# 1962 Corvette: Service Bulletin: Aluminum Powerglide Shift Problems

**Source:** Chevrolet Technical Service Bulletin

**Bulletin No:** DR #514

**Date:** January 16, 1962

FIGURE 1- 327 AND 283 POWERGLIDE TV LINKAGE COMPARISON

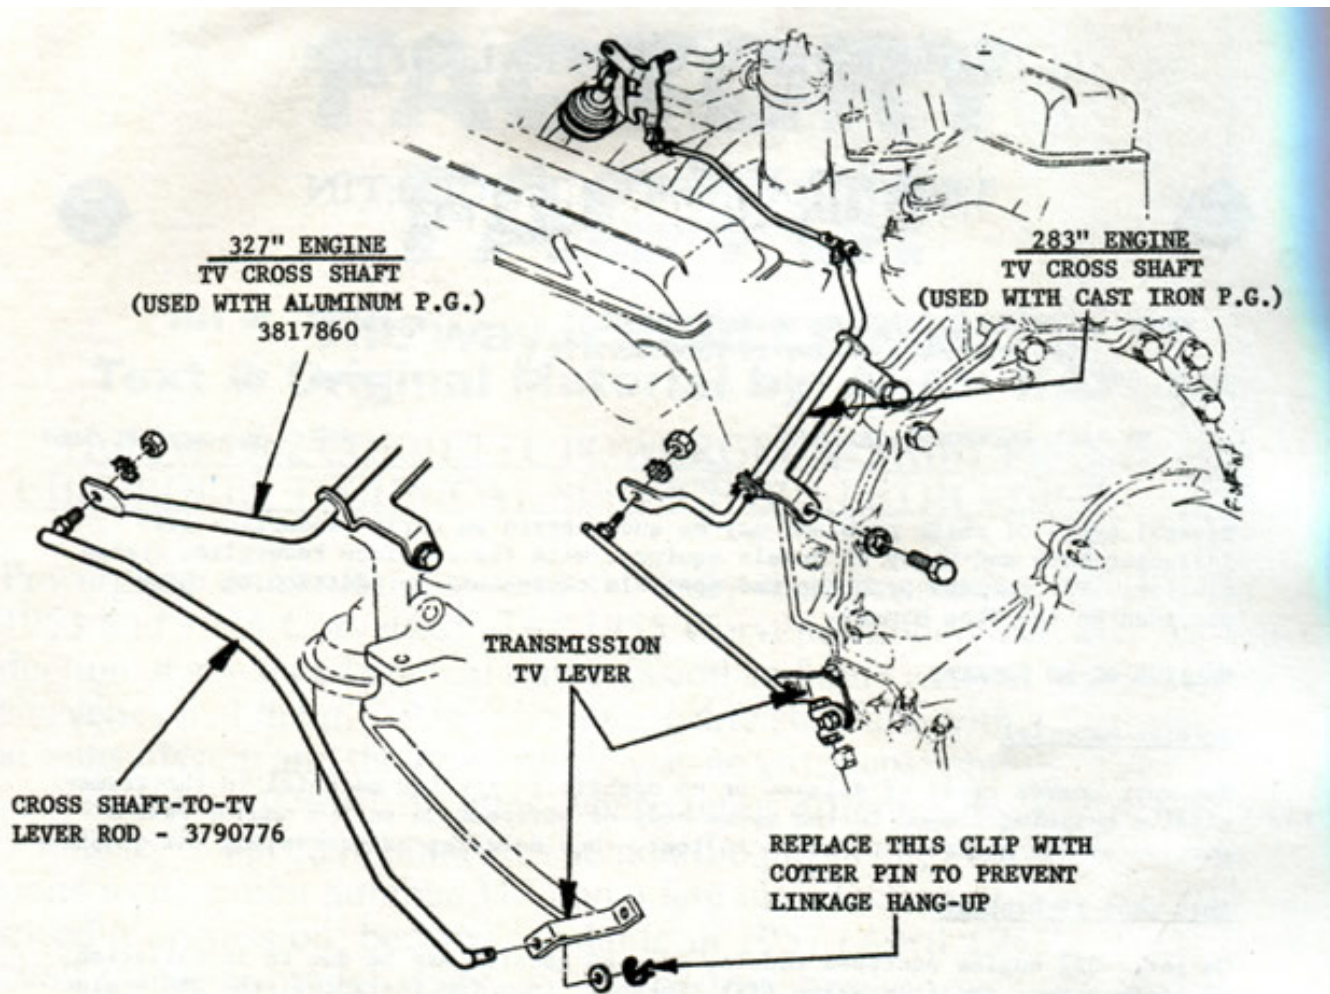
On early 327 engine equipped models, delayed upshift may be due to installation of an incorrect throttle valve (TV) linkage. In a few instances, the 283 engine cross shaft was installed instead of the correct TV cross shaft, 3817860. The TV cross shaft are easily identified as the 283 version has a bend in its outboard lever whereas the 327 cross-shaft lever is straight in this same area. (Figure 1). If the TV cross shaft was incorrect, also check the cross shaft-to-TV lever rod. As shown in Figure 1, this rod, 3790776, is formed on 327 engine applications as compared to the straight rod used on 283 engine versions.

Cross Shaft, TV (327 engine) ---- 3817860

Rod, Cross Shaft-to TV (327 engine) ----- 3790776

FIGURE 2 - ALUMINUM POWERGLIDE DIPSTICKS

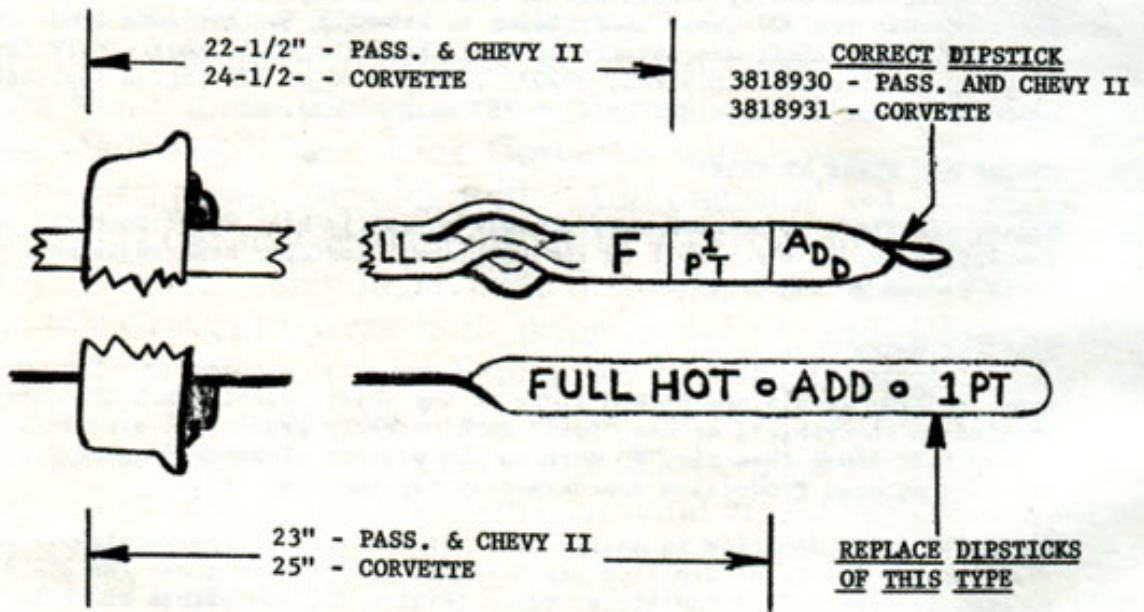
When checking complaints of RPM flare at the shift, first check the dipstick installed in the vehicle as the "Full" mark on early production dipsticks is approximately 1/2" lower than the "F" mark on the present dipstick (Figure 2). The later dipstick entered Production approximately September 4, 1961.

The early style dipstick is easily identified as its bottom section is absolutely flat whereas the later dipstick has a formed bridge just above the oil level markings to keep it centered in the filler tube. (Figure 2). A further check is to measure the distance from the top of the cap to the "Full" mark; on

Passenger and Chevy II dipsticks, this distance is now 22-1/2", as compared to 23" on the earlier dipsticks. This distance on the Corvette dipstick is now 24-1/2" as compared to 25" on earlier units.

Replace all early dipsticks with the later part when found and add oil as

required to raise the transmission oil level to the "F" mark. The later dipstick for 327 engine passenger cars and all Chevy II Models is 3818930; for Corvette, 3818931.
